AGENDA
Village of Chenequa
Monday, August 10, 2026
31275 W County Road K, Chenequa, WI 53029

Project Description: Proposed Stormwater Management Plan

Re: Stormwater Management Plan (SWMP) Review of 31795 West Muscovy Road
Drainage Improvements
Village of Chenequa, Wisconsin (Village)

Project Description: Proposed modification to existing structures and proposed landscape plan

ISSUED FOR REVIEW		GRADING & EROSION CONTROL PLAN		SITE IMPROVEMENT PLANS FOR ZIEGLER PROPERTY	
PLAN DATE	12.14.23	NO.	REVISIONS	BY	DATE
DESIGNED BY	TCL				
SCALE	0" = 40'				
PROJECT NO.	23.0016				
SHEET NO.	C301				
				CHENEQUA, WI	
				LYNCH & ASSOCIATES	
				ENGINEERING CONSULTANTS, LLC

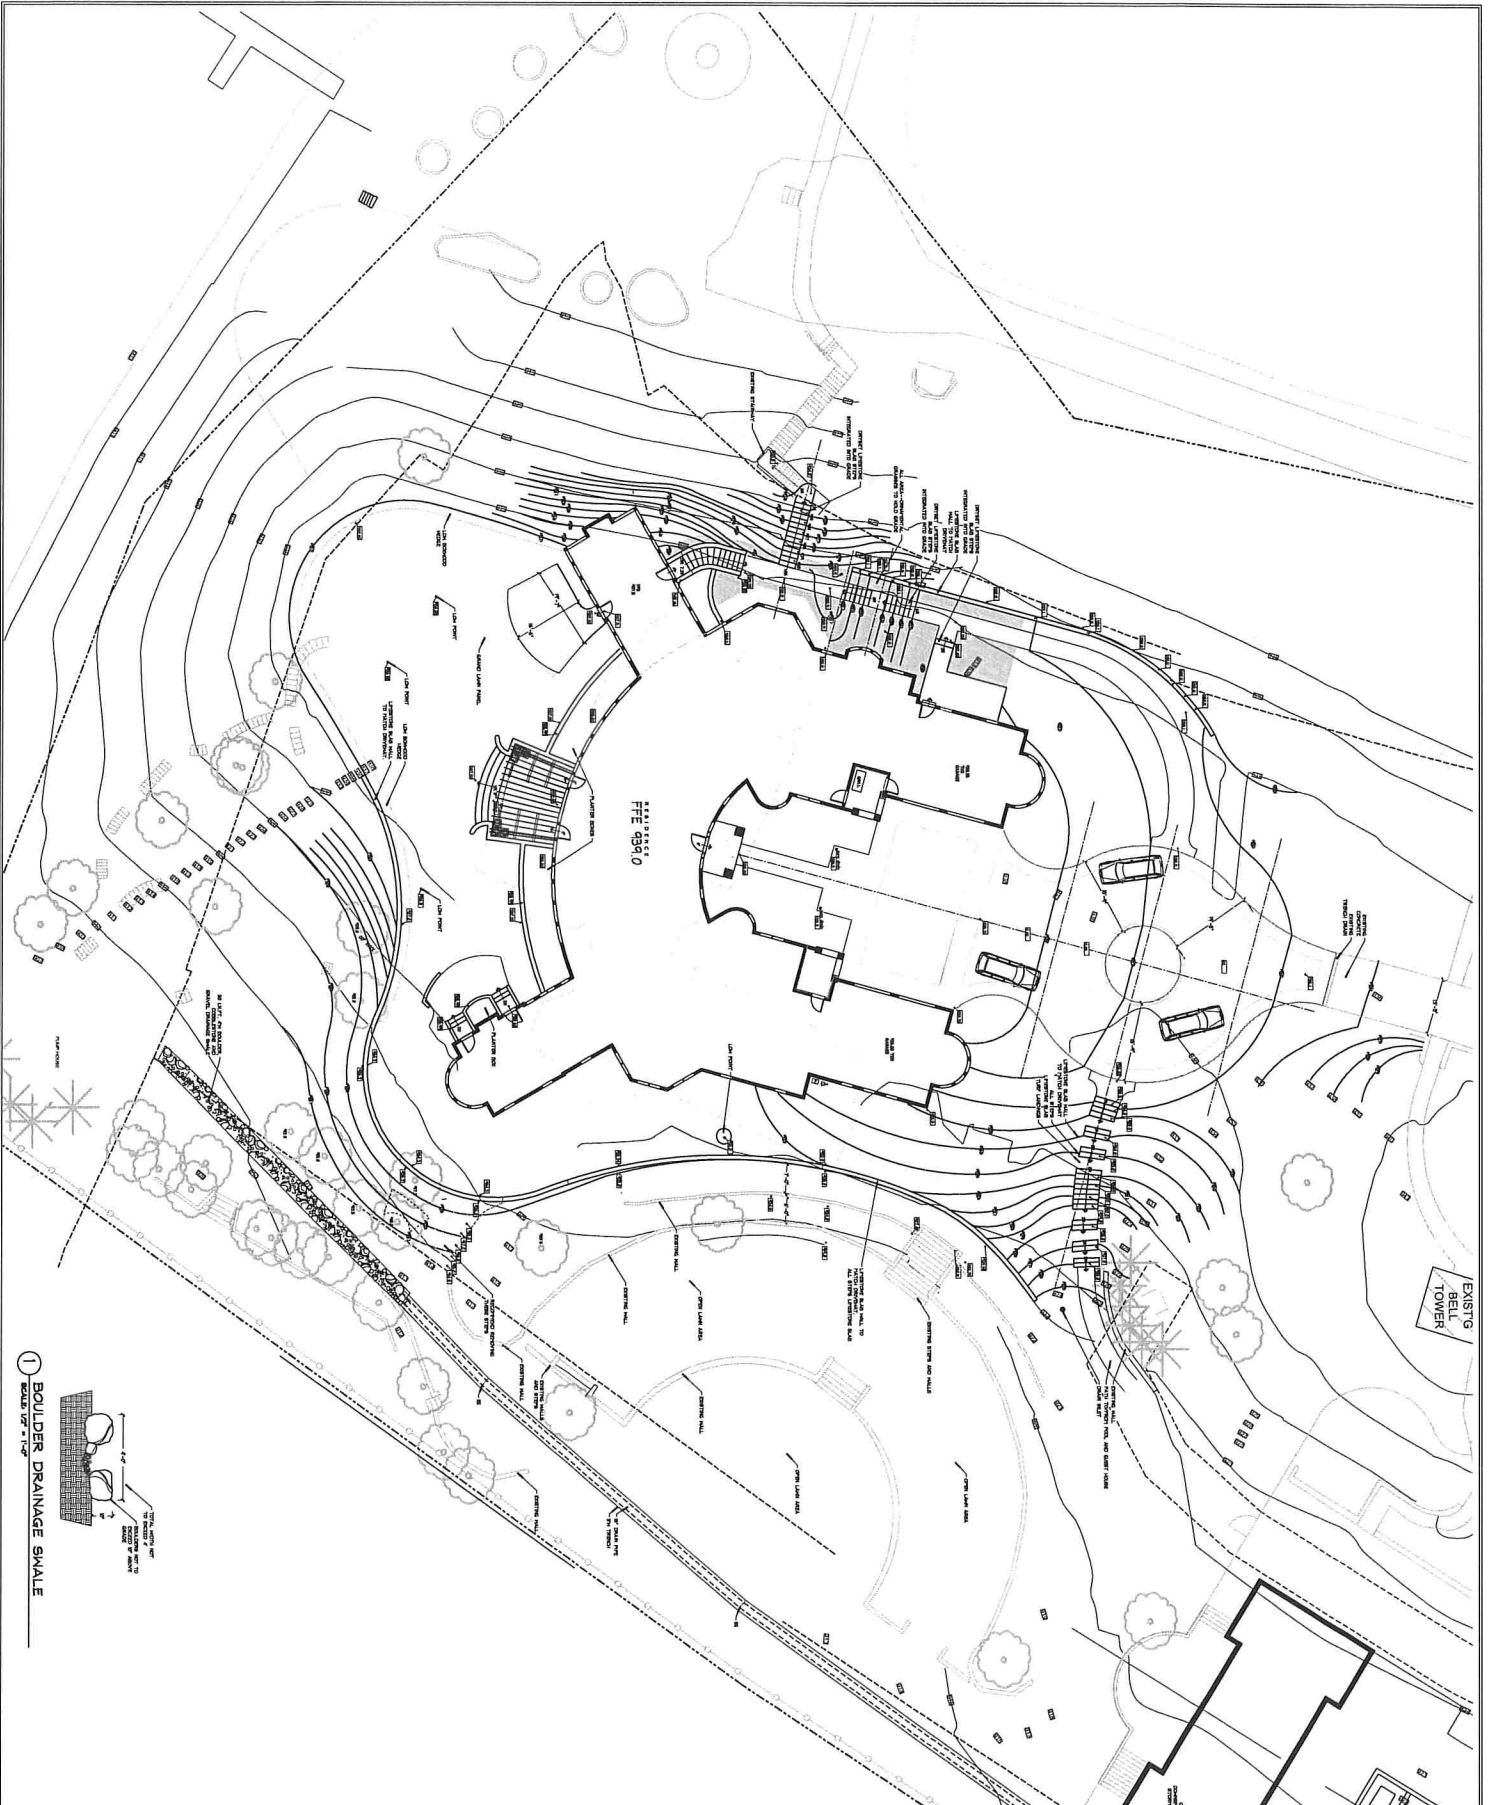
- a. Change any references to "City" to be "Village."
 - b. Add signature lines for the Village and Developer.
 - c. Identify maintenance vehicle access on Exhibit B.

- d. Remove redundant operation and maintenance pages from Exhibit D.
2. When redevelopment includes the addition of impervious areas, the site is typically regulated using a combination of redevelopment and new development stormwater management standards, prorated accordingly. Given this redevelopment is adding impervious area, a portion of the site should meet the 40 percent total suspended solids (TSS) reduction standard for redevelopment, and the other portion should meet the 80 percent TSS reduction standard for new development. It appears the general strategy employed to meet stormwater quality standards is to treat a majority of off-site flows to offset undetained on-site areas. Under no-control conditions, the site produces approximately 836 pounds of TSS annually; the proposed stormwater features capture approximately 1,167 pounds of TSS from both on-site and off-site areas. Therefore, the total TSS reduction amount, in comparison to TSS produced from on-site runoff, exceeds redevelopment and new development TSS reduction standards. No revisions or updates are needed.
